STAFF REPORT: JULY 14, 2021 MEETING

APPLICATION NUMBER: 21-7360

ADDRESS: 1321 LABROSSE

SCOPE: WINDOWS REPLACED WITHOUT APPROVAL

Rear Elevation

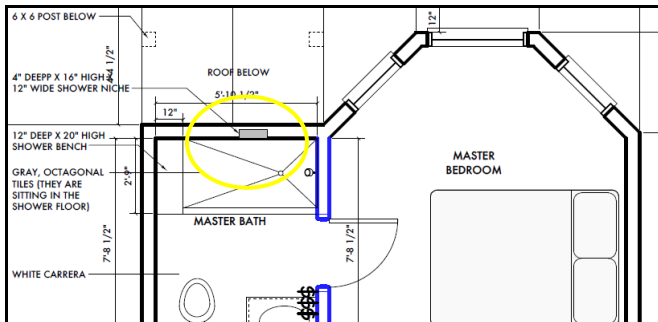
- Removal of one historic, wood double-hung window on the second story (far left), and installation of one double-hung, one-over-one vinyl sash (clear glass), color: white
- Removal of one historic, wood double-hung window on the first story, resizing of opening, and installation of one vinyl awning window, clear glass, color: white
- Removal of one historic, wood double-hung window on the second story (far right), and installation of glass block.

Applicant's 2021 Floor Plan – "Scheme G"

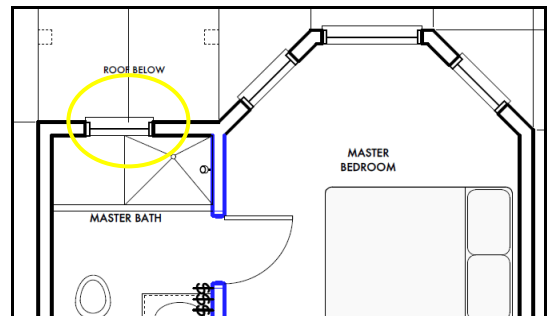
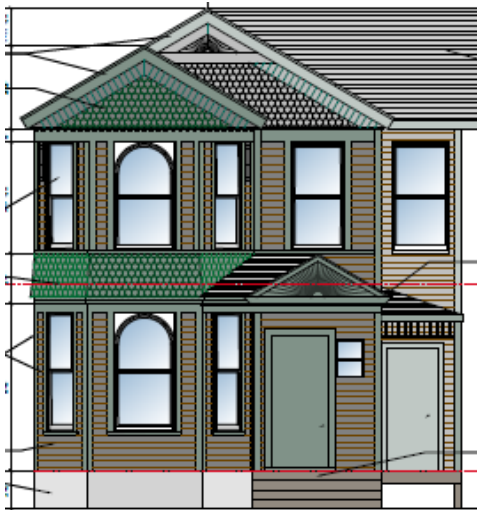
- The second story floor plan ("Scheme G" – included with the applicant's submission materials) shows the front elevation second story window gone, in contrast with the floor plan submitted as part of the 2019 rehabilitation application.

Applicant Rendering

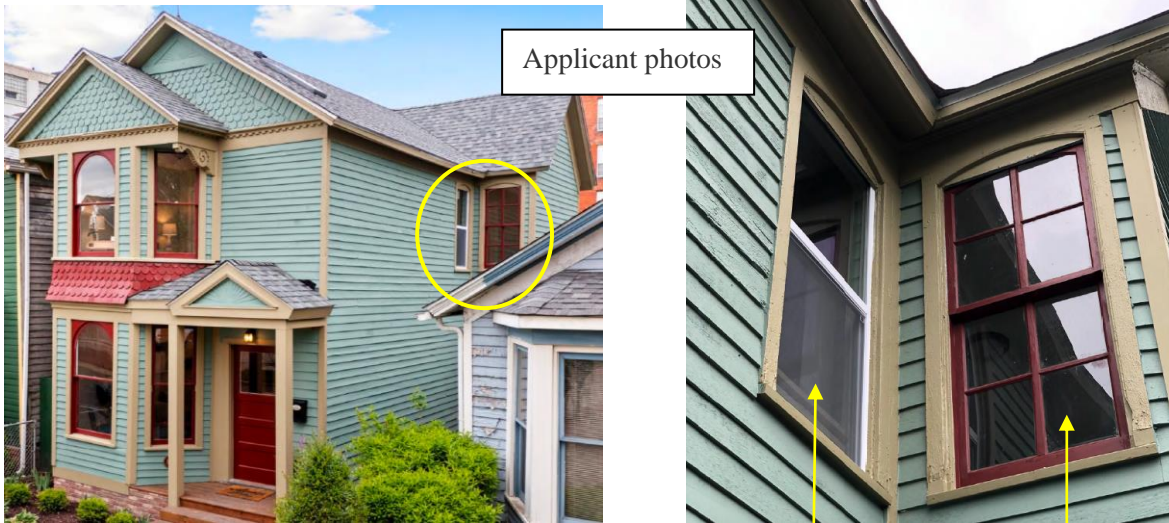
- The façade of this house offers a multitude of patterns and angles, in line with the Queen Anne architectural style. The window opening above the front porch (as shown in the below-left rendering) completed the horizontal line (or rhythm) of windows at the second story, as well as creating a vertical balance with the first story openings. The removal of this window opening created a flat void within this highly detailed façade.

It is staff's opinion the removal of the four wood windows and installation of vinyl windows and glass block, as well as the removal of the two front elevation window openings, has altered the features and spaces that characterize the property. Staff therefore recommends the Commission deny a Certificate of Appropriateness for the work as proposed because it does not meet the Secretary of the Interior Standards for Rehabilitation and the Elements of Design for the district.
